RETREAT AT PRAIRIERIDGE FILING NO. 1

CONSTRUCTION PLANS

FEBRUARY 2025

17'X4' OUTLET BOX DETAIL
SCALE 1" = 2'

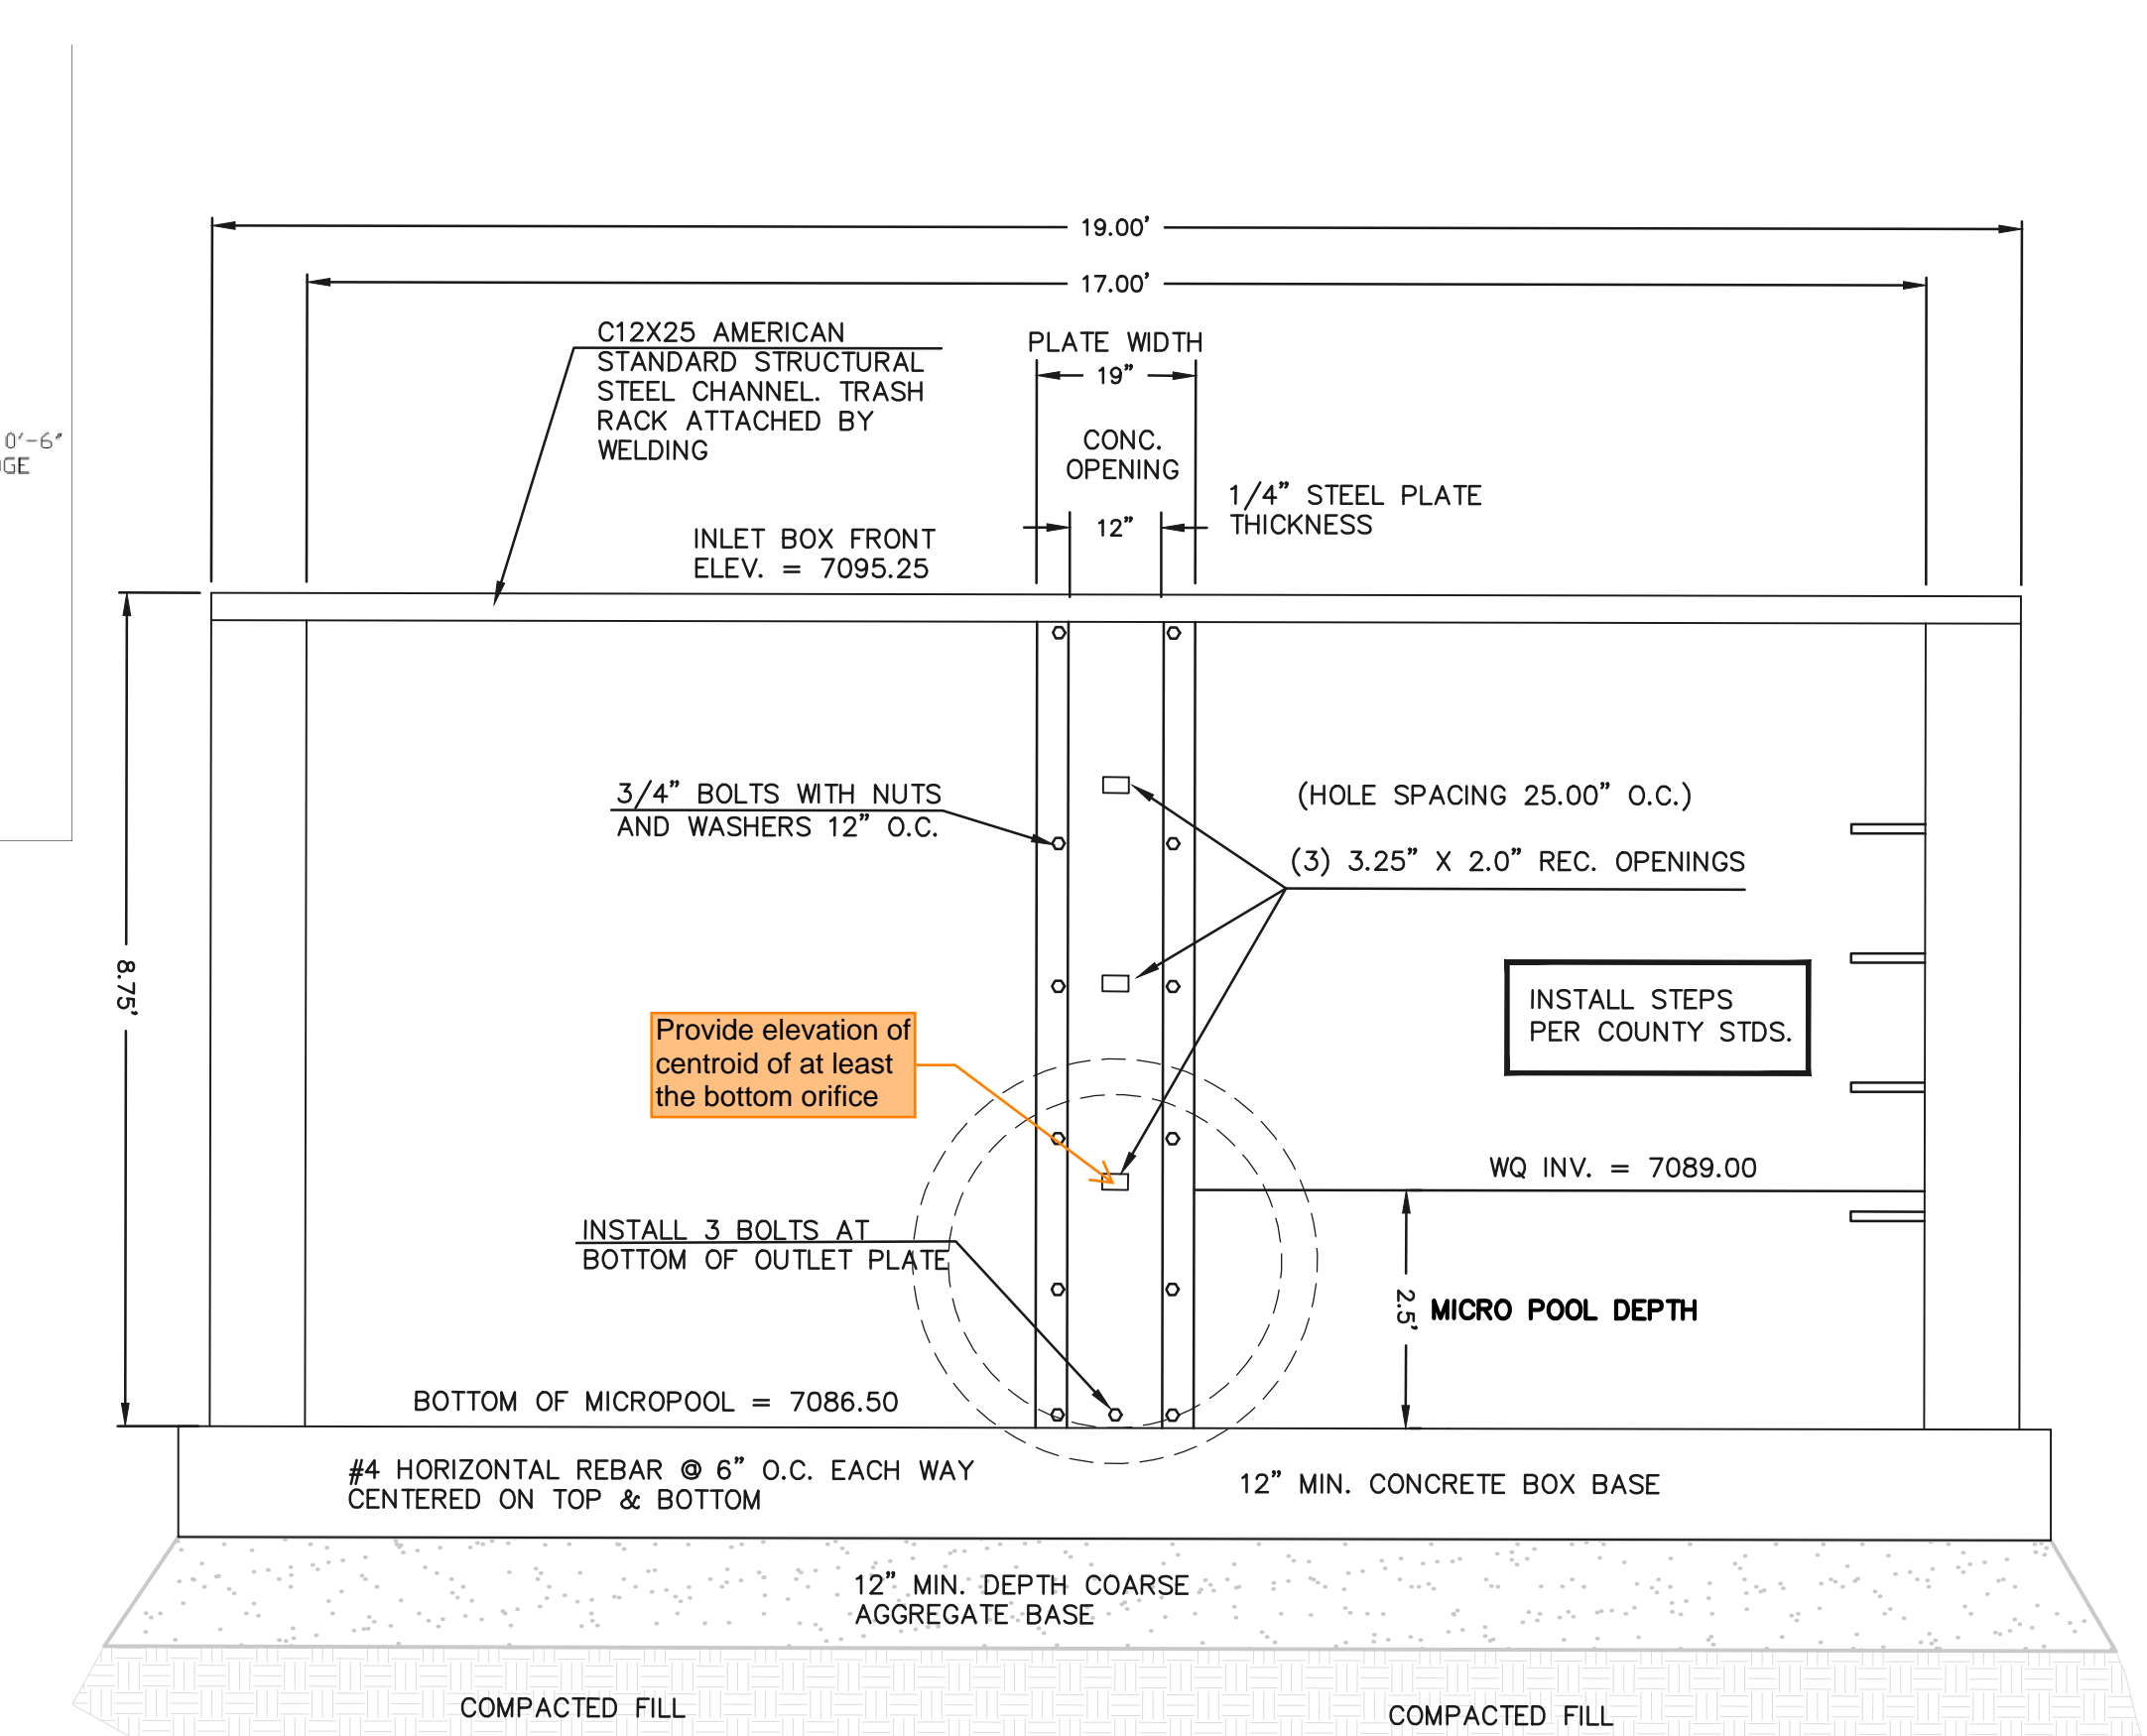
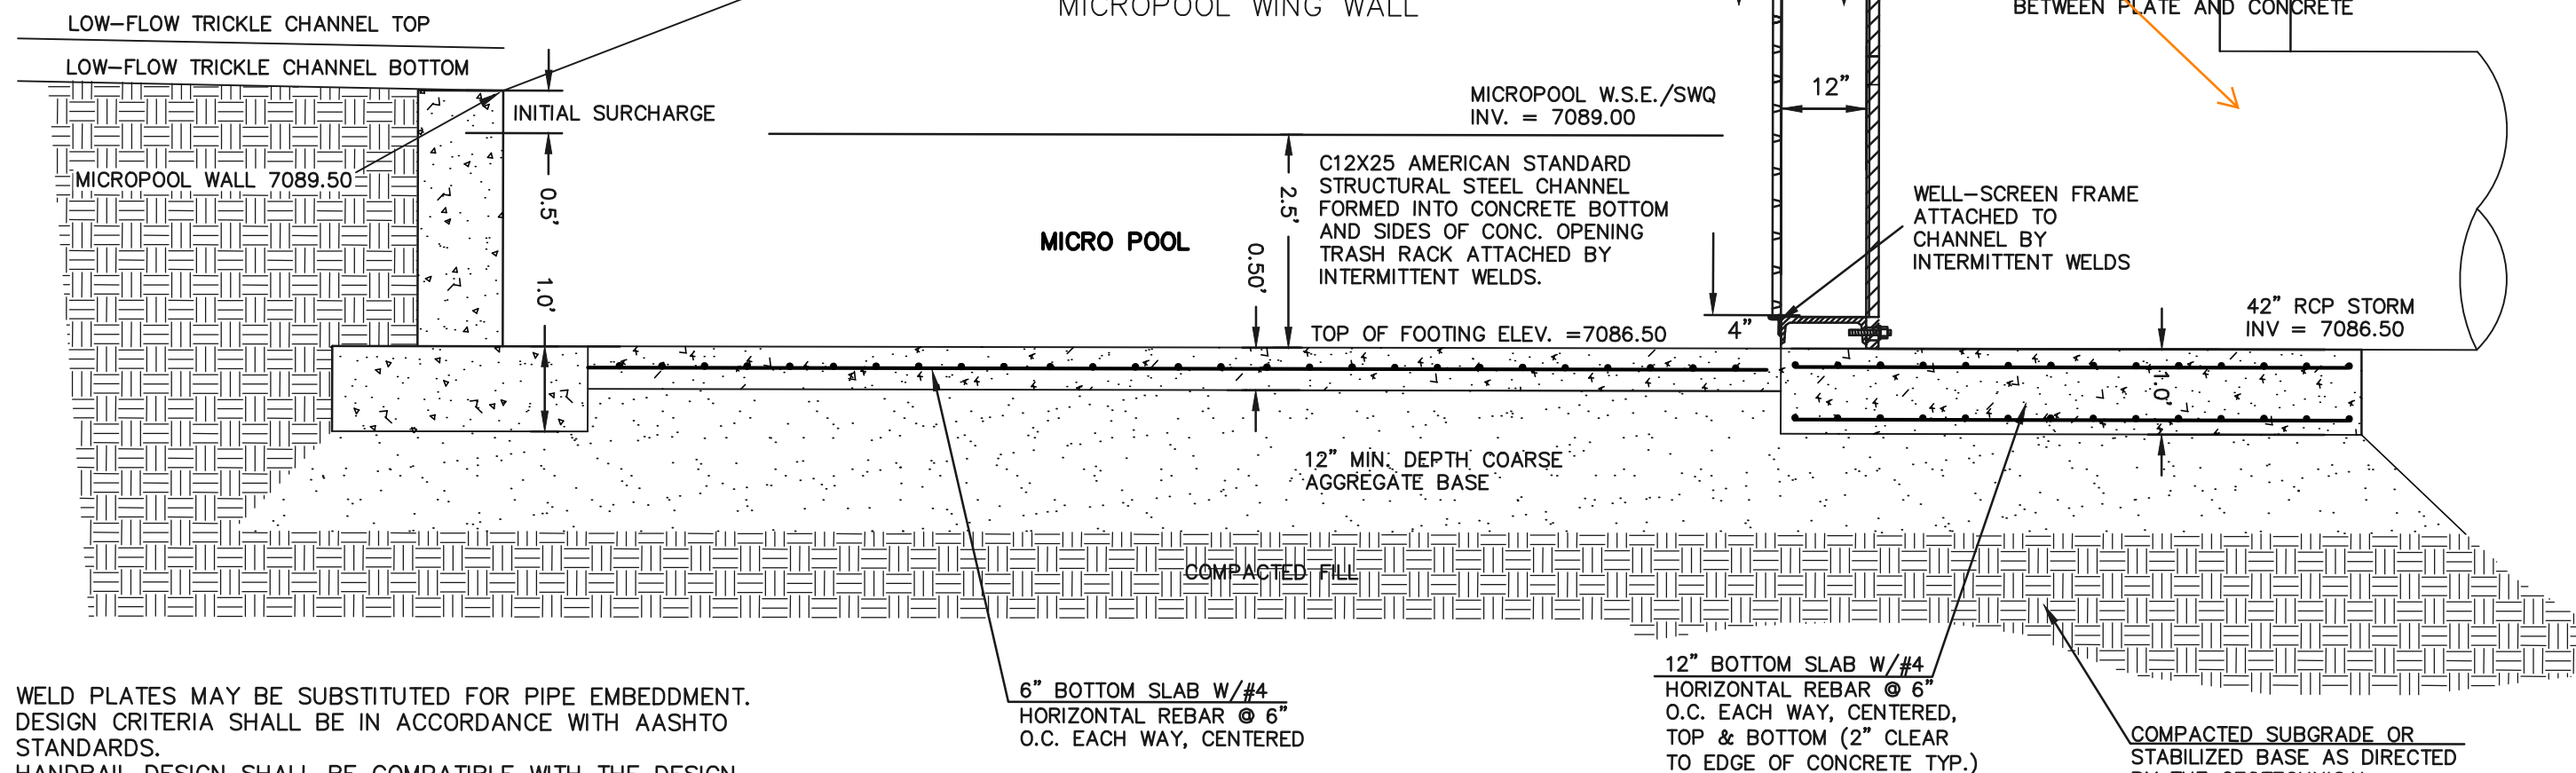
Show restrictor plate per drainage report calcs and provide detail.
